Fabrication Notes  
Board Outline

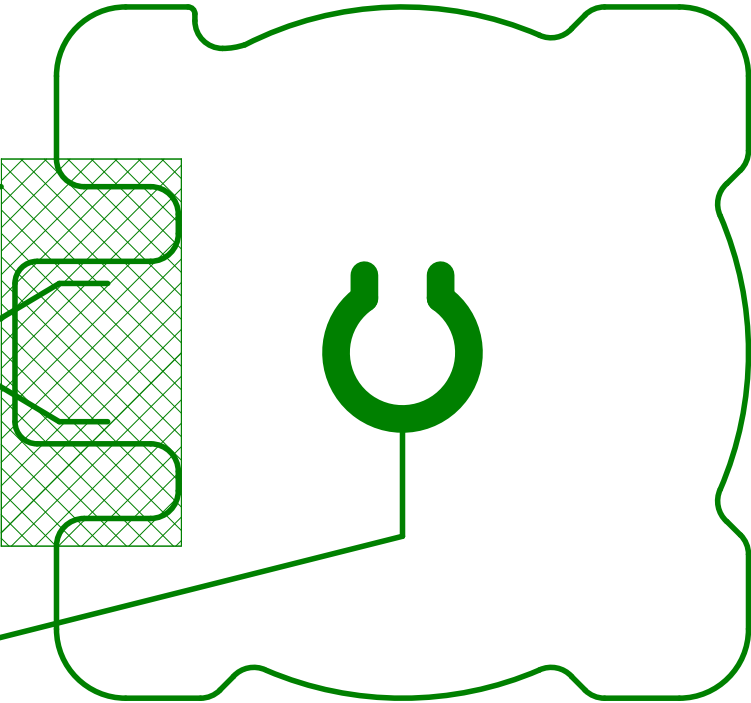
no board edge pips/  
rat's teeth/mouse bites  
in this region - make  
sure board edge is clean

non-plated slots x2

"horseshoe shaped"  
board cut-out
